Re: Point Pleasant Pumping Station

Re: Application No. NAPOP-R-80-0534-3
Point Pleasant Pumping Station

Since submission of the referenced application on July 18, 1980, we have determined that certain revisions should be made in the plans for the project to improve the efficiency of the facility and to reduce to a minimum any environmental impact. These revisions are described in the following paragraphs and the reasons for each are given.

DELAWARE RIVER FLOW VELOCITIES

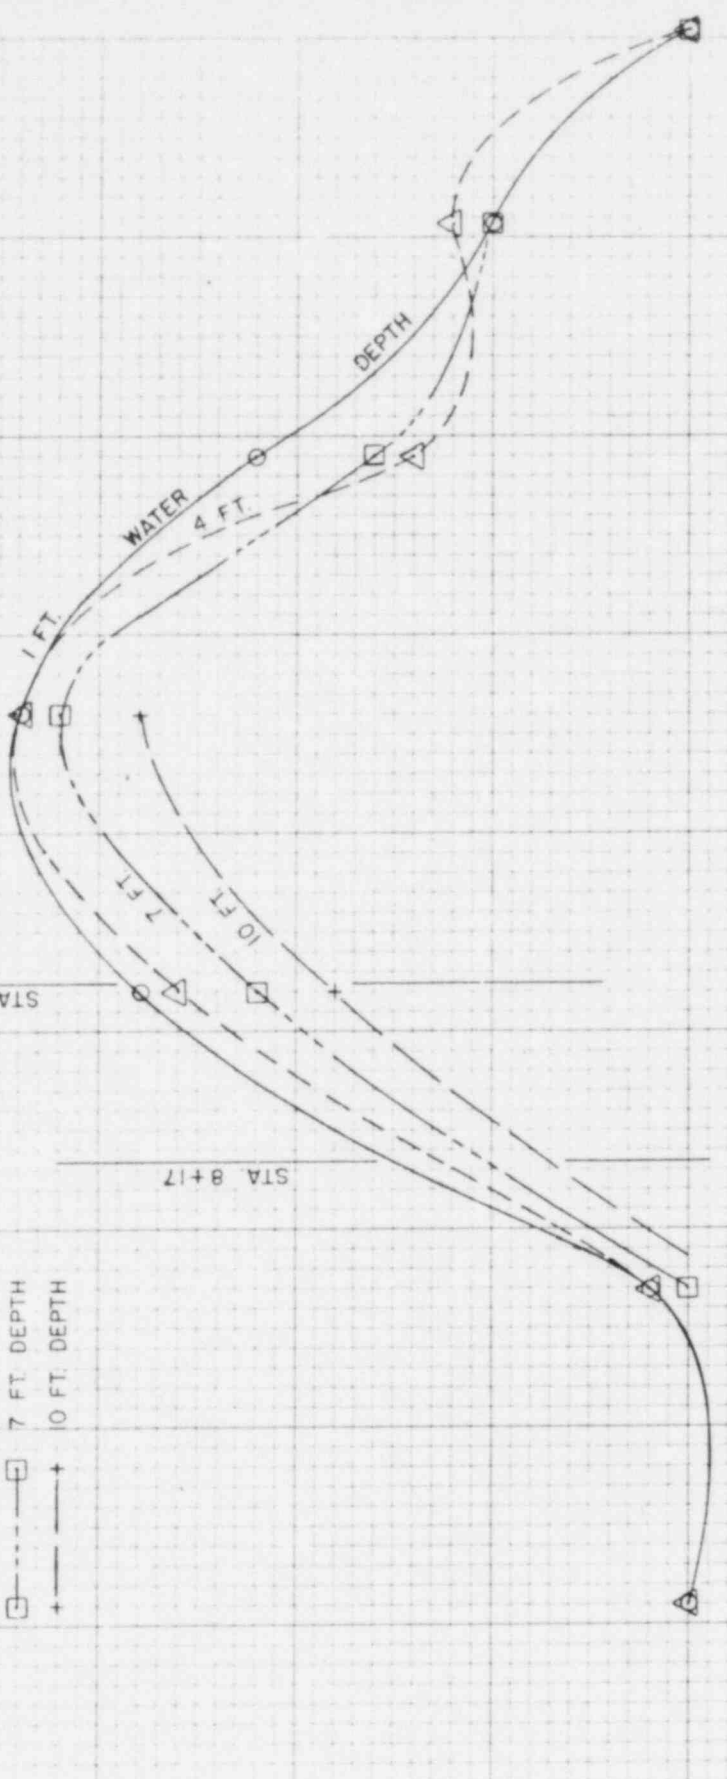
fish spawning period of March thru June and, during that period, greater flows can be anticipated with even higher River flow velocities. In fact, flow velocities during the spawning period should be higher than those plotted on Exhibit No. 3 for a flow of 4,500 cfs which velocities are indicated by the lines marked "7-23-81" at the top.

The velocity measurements plotted on Exhibits Nos. 1, 2 and 3 were made by the Environmental Services Division - RMC on the days indicated.

RATING CURVE - POINT PLEASANT INTAKE

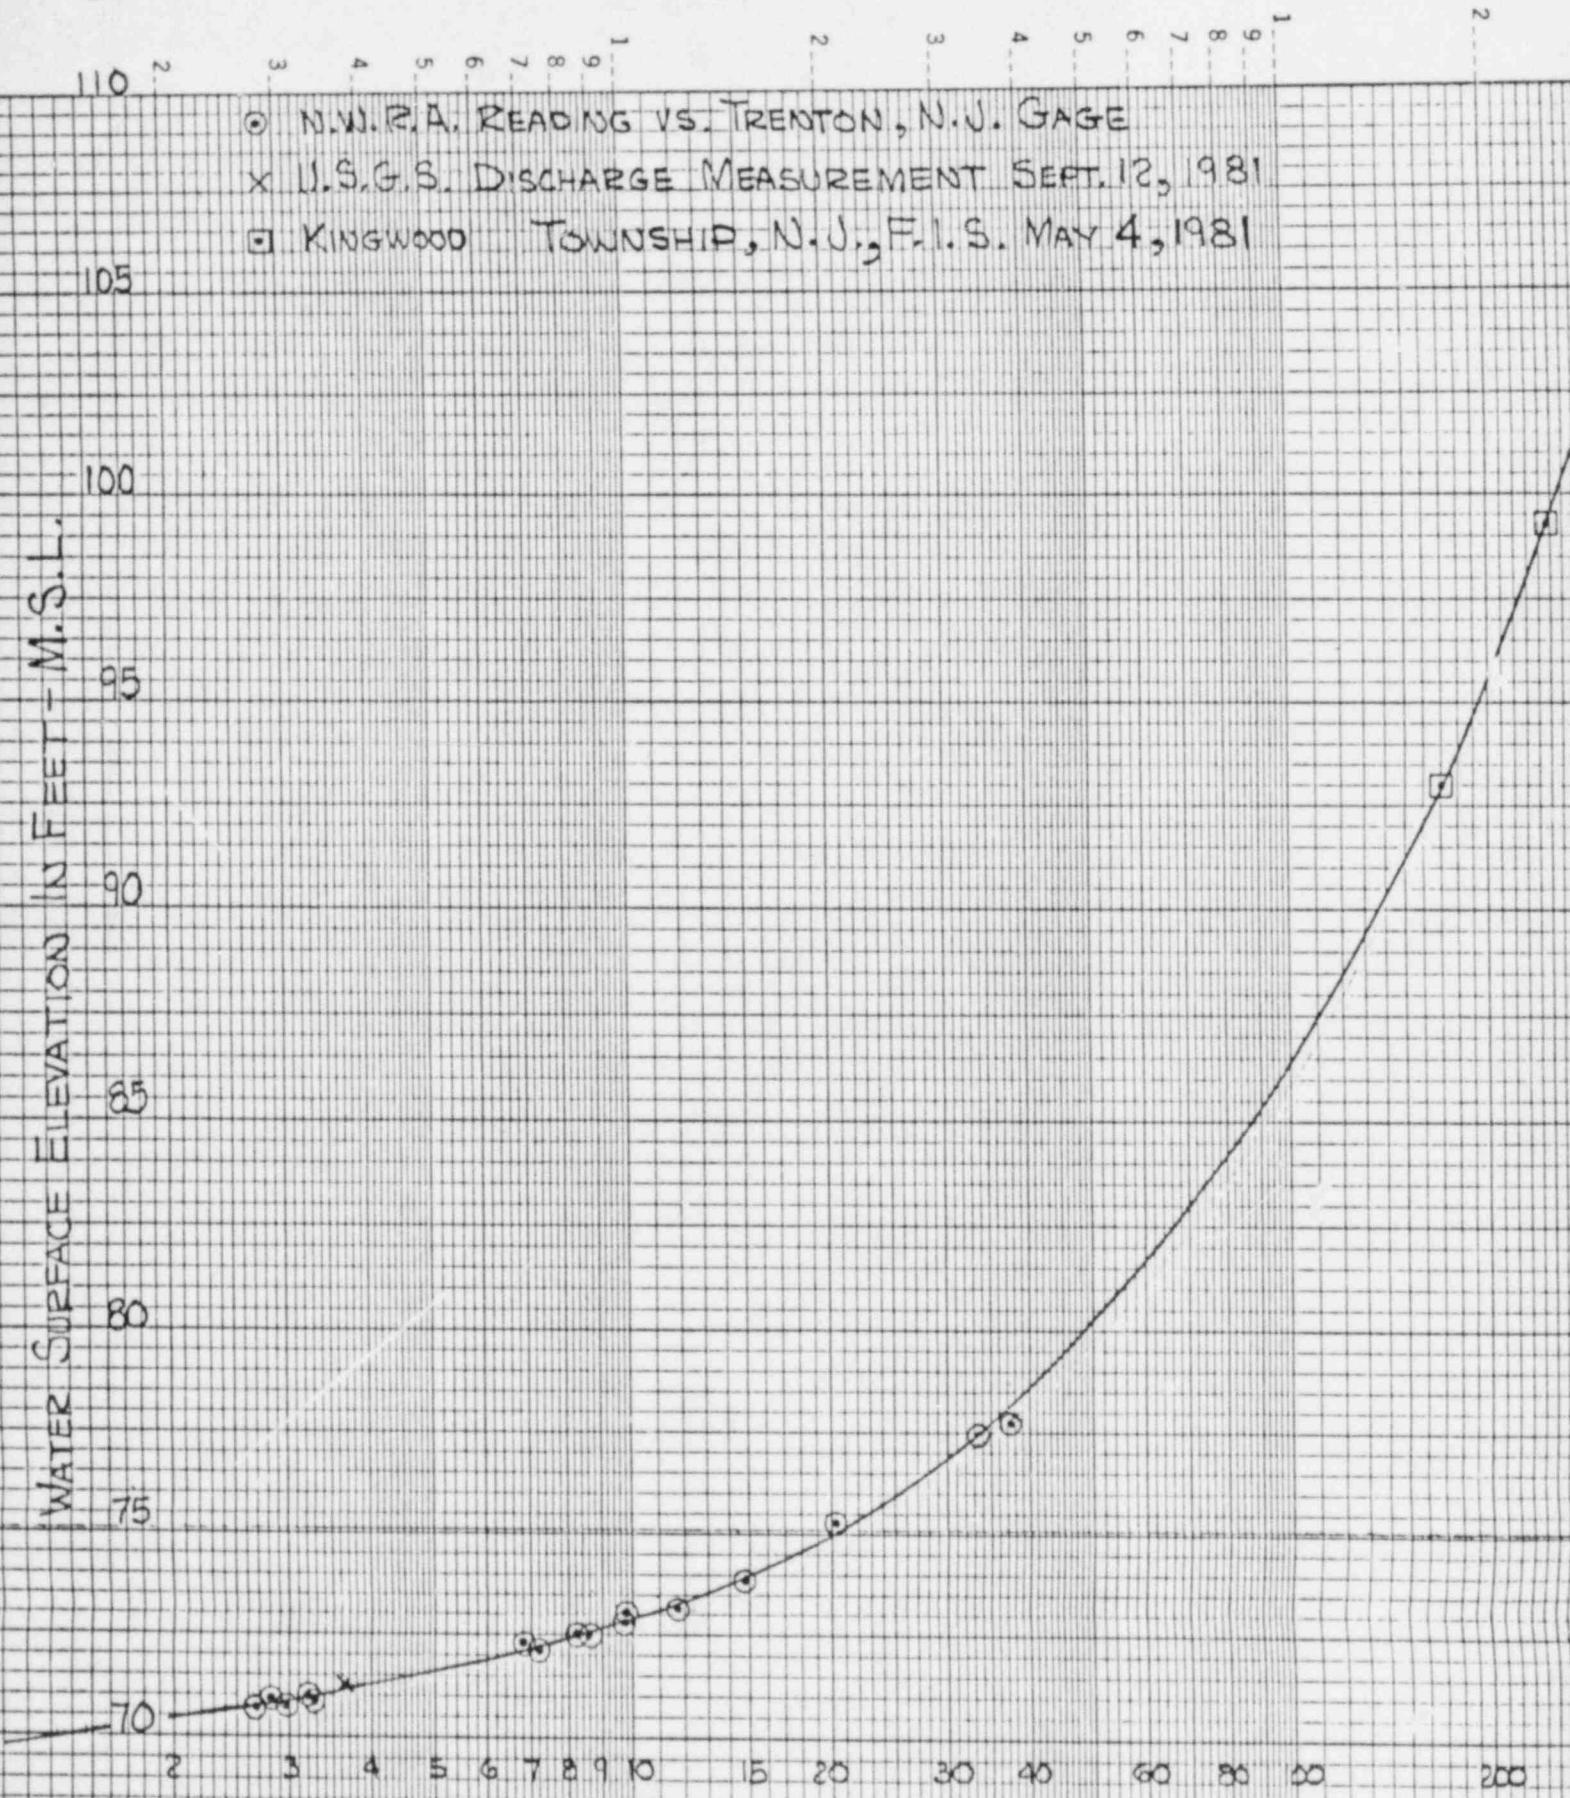
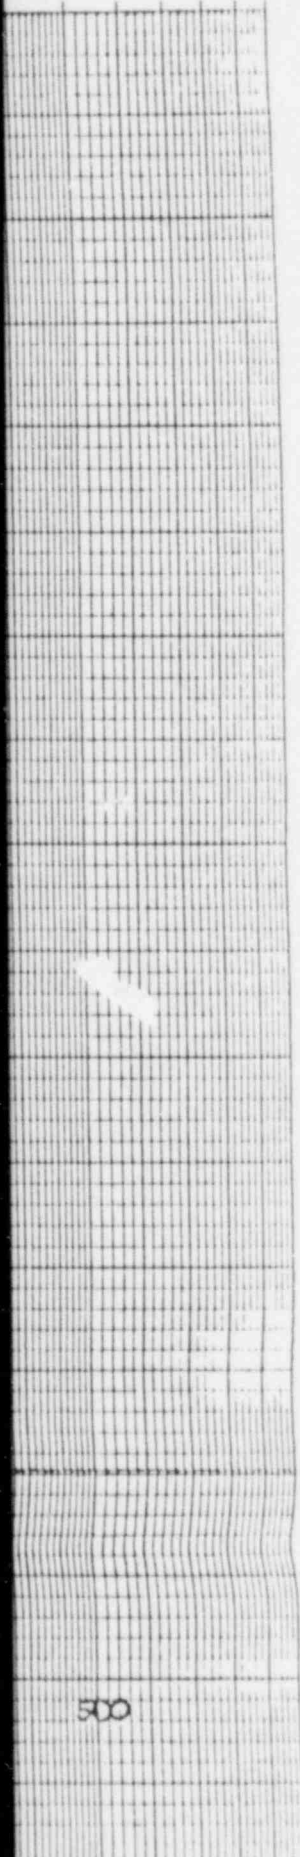
Sheet No. 3 of Exhibit No. 7 explains how the minimum, normal, and maximum water levels were derived for the Delaware River at the PPS site. The term minimum water level, as used herein, refers to a design condition; that is, this is the lowest water level when the withdrawal rate would be at the maximum.

Rating. The above data were plotted on semi-log graph paper. A rating curve based on these points has been drawn and is identified by the date 12/10/81. A print of this graph is attached.

**POINT PLEASANT PUMPING STATION SITE
LIMITS OF WETLANDS AND EFFECTED AREAS**

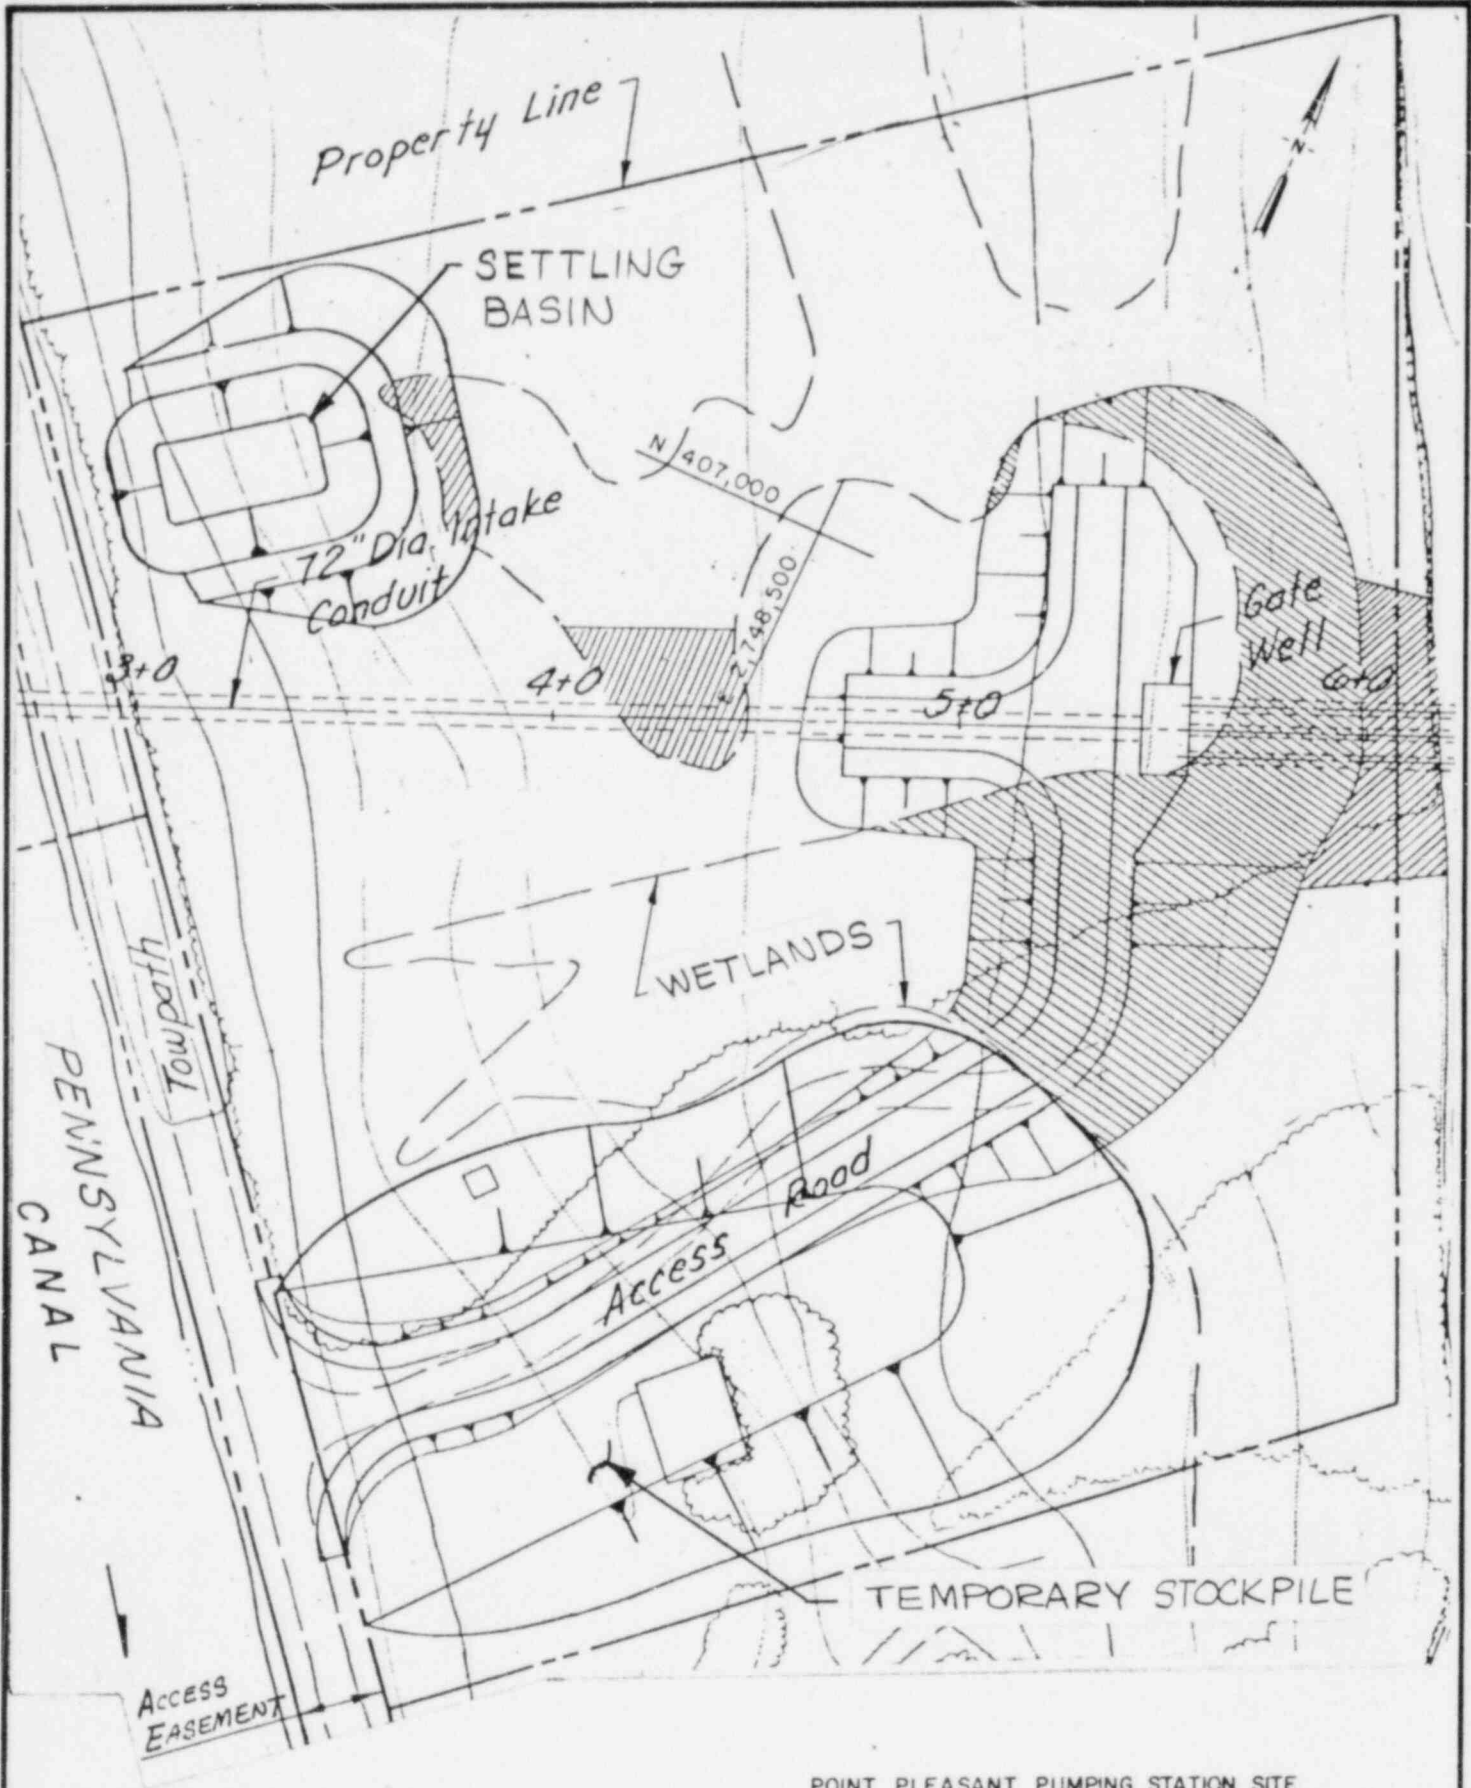
In accordance with this goal, NWRA has made every effort to minimize the impact of construction on wetlands. In order to give full consideration to the effect of the installation on the wetlands, the actual limits of the wetlands on the Project site were staked out by a biologist and these limits were then surveyed and placed on the site plan. They are shown on Exhibit No. 5, and on Exhibit No. 15. Through judicious design and planning, the total area of affected wetlands is only 0.30 acre which is about 1/3 of the 0.93 acre of wetlands at the site. Of this, only 0.22 acre of wetlands will be permanently affected by placement of fill. The ground surface of the remaining 0.08 acre of affected wetland will be restored to original grade and should return to pre-construction conditions.

As shown on Exhibit No. 15, the alignment of the intake conduit passes between the two principal wetland areas, minimizing the amount of wetlands affected. The fill around the gate well and for the access road covers some of the wetland area but these facilities are essential for the operation of the Project. Also, some wetland area must be excavated for installation of the intake conduit. There will be a settling basin in the upper part of the property near the Canal towpath, during the construction period. The settling basin will affect only 0.01 acre of wetlands and is an essential structure for sediment control. There will be no temporary stockpiling of excavated materials on wetland area.
